# **CONNECTION ASSESSMENT & APPROVAL PROCESS**

## **ASSESSMENT SUMMARY - ADDENDUM**

**Project: Merivale TS  
Replace 115kV Oil Breakers L1L5, L1LT22,  
and L3L12, and Associated Breaker  
Disconnect Switches**

**CAA ID: 2002 – EX109**

Figure 1 - Merivale TS 115kV Switchyard

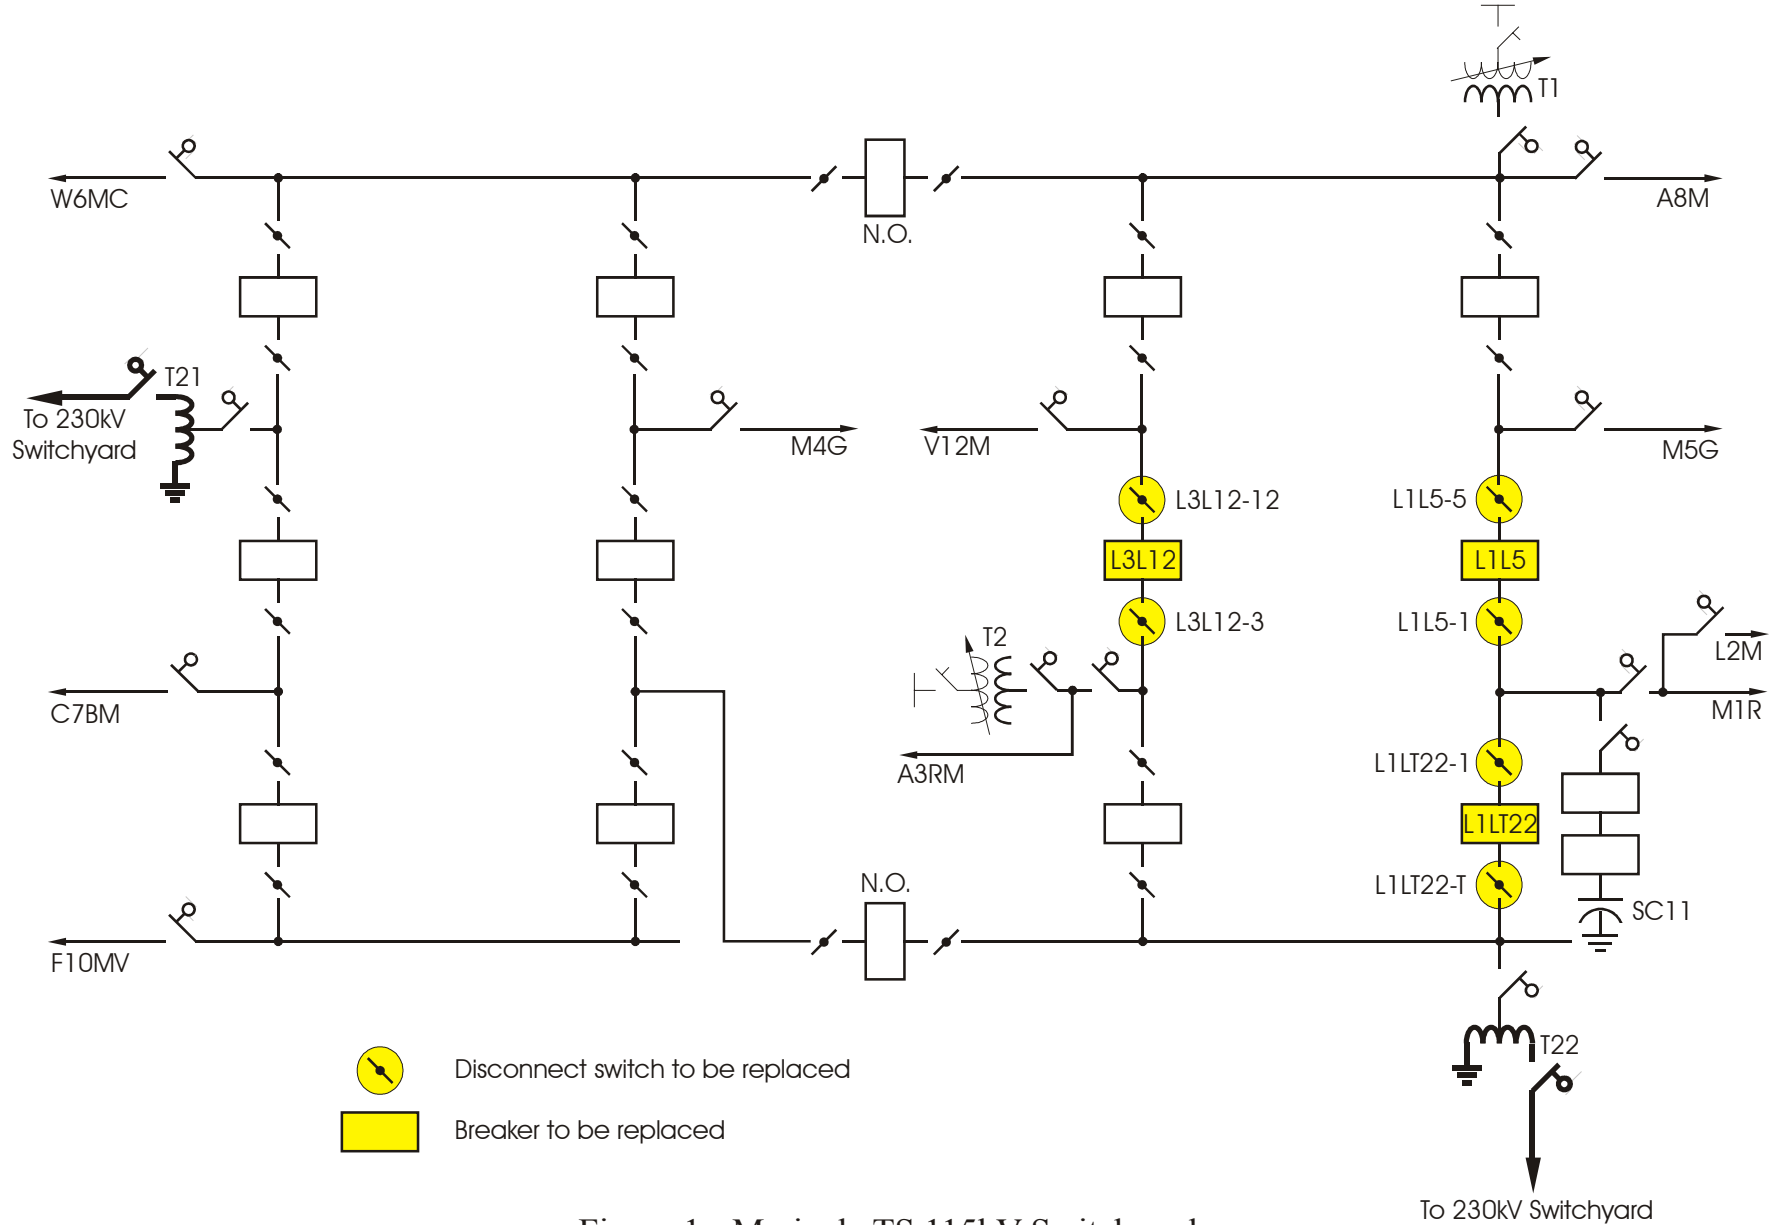
Hydro One Networks Inc. is proposing to replace three existing 115kV 1,200A bulk oil circuit breaker with 20.2kA symmetrical fault current interrupting capability and their associated 1,200A disconnect switches with new 145kV SF<sub>6</sub> circuit breakers and new 138kV disconnect switches. The breakers and disconnect switches that are to be replaced are identified in Figure 1.

The proponent is proposing to replace three of the eight 115kV 1,200A 20.2kA oil breakers and their associated disconnect switches with new SF<sub>6</sub> breakers and disconnect switches of higher ratings. Although the new breakers have higher ratings than the existing units and are definite improvement, Merivale TS fault level rating remains at 20kA as defined by the remaining 20.2kA oil breakers.

This proposal is essentially a like-for-like replacement of existing facilities and would not have any adverse impact on the operating reliability of the IMO-controlled grid.

Based on the above assessment, it is recommended that a Notification of Approval for this proposal be issued to the applicant.
